December 8, 2008

**Re: INDIAN POINT ENERGY CENTER ACTIVE FAILURE ON PASSIVE  
FAILURE**

John Boska on your staff e-mailed me a copy of his letter dated December 4, 2008, transmitting Amendments 257 and 238 to the operating licenses for Indian Point Units 2 and 3 respectively. Those amendments approved a change to the passive failure assumed during the first 24 hours after a postulated loss of coolant accident (LOCA).

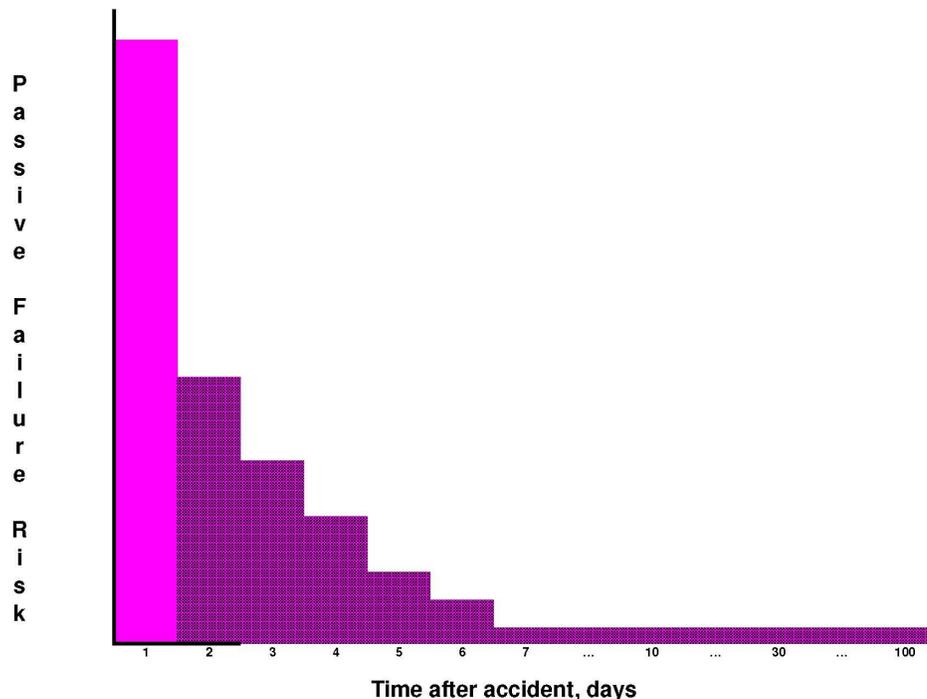
The ECCS systems in this case have a post-LOCA mission time of longer than 24 hours. It may be 30 days or it might be as long as 100 days (I could check the Indian Point design and licensing bases, but the question seems moot now that NRC has already approved the amendments). The following chart illustrates the risk of passive failure of the piping in the LOCA recirculation system as a function of time after the accident.

Curiously, although the probability of passive failure of the recirculation system piping is lowest from Day 2 through the end of the mission time, the amendments retain such failure within the Indian Point licensing and design bases. And although the piping passive failure probability is highest on Day 1, the amendments exclude it. How bizarre.

I hasten to point out that the values in the chart are for illustration only and may not accurately portray the actual (i.e., non-fiction) risk at Indian Point. But the relative portrayal is accurate in that the risk is highest on Day 1 and lower thereafter.

It very easily could be that the passive failure risk on Day 1 exceeds the cumulative passive failure risk from Day 2 through the end of the recirculation system mission time. If so, or if the Day 1 risk even approaches the cumulative risk from the remainder of the mission time, it seems absurd and improper for the NRC to dismiss the Day 1 risk on an undocumented probability basis and yet retain the Day 2-plus risk.

On technical and scientific grounds, the recirculation system piping passive failure should either be totally within or totally outside the LOCA licensing and design bases. Excluding the first 24 hours when the failure probability is highest make no technical or scientific sense.
